Facility Permit Program Revision Submittal Requirements and Application

Contact name Nicholas Sukkau
 Address 501 N Dixon St.
 City Portland State OR Zip Code 97227
 Phone 503916-3195 Email nsukkau@pps.net
 Value of revision \$0 Issued FPP building permit # 20-143852-000-00-FA
 Job site address 5800 SE Division St, Portland, OR 97206

Project Title: **ATKINSON SCHOOL
BOILER
FLUE REPLACEMENT**

**ROOF PLAN -
STRUCTURAL**

S2.02

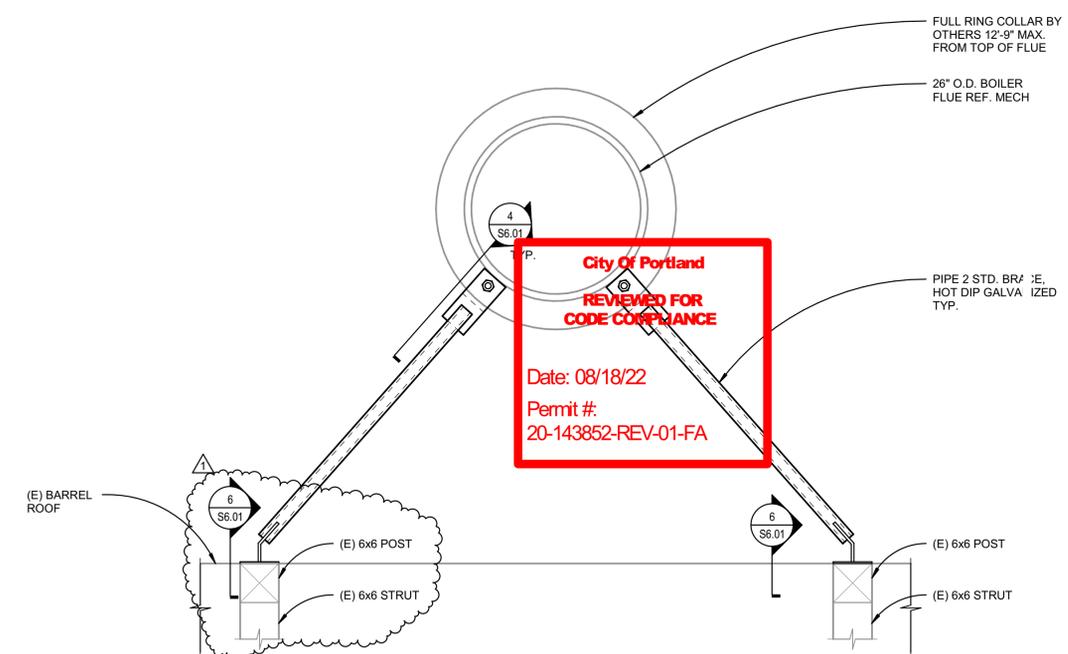
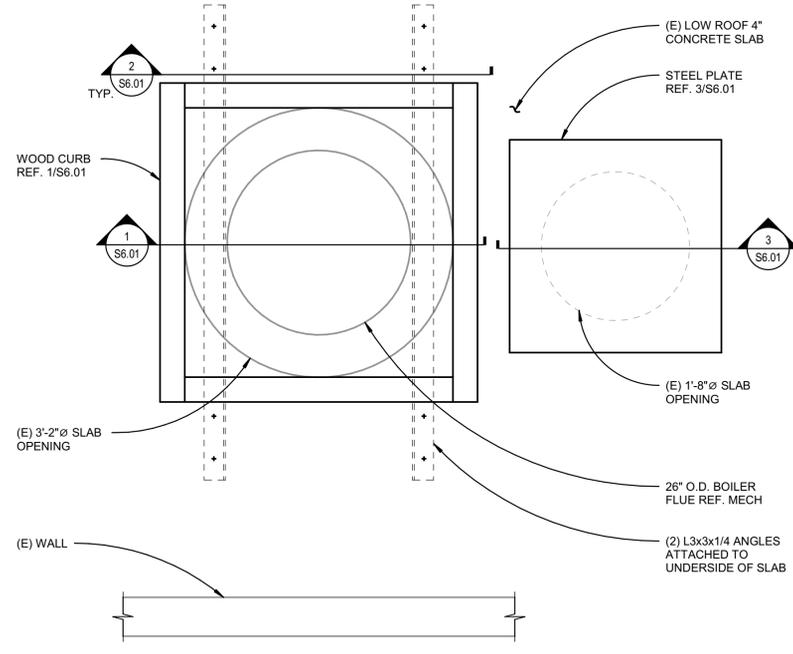
Removed the requirements for special inspections, per OSSC Section 1704.2, Exception No. 1, due to the minor nature of the construction. Revised connection of brace to show framing into wood wall (type of existing construction). Removed references to existing masonry and epoxy anchors, as existing construction was found to be wood not masonry.
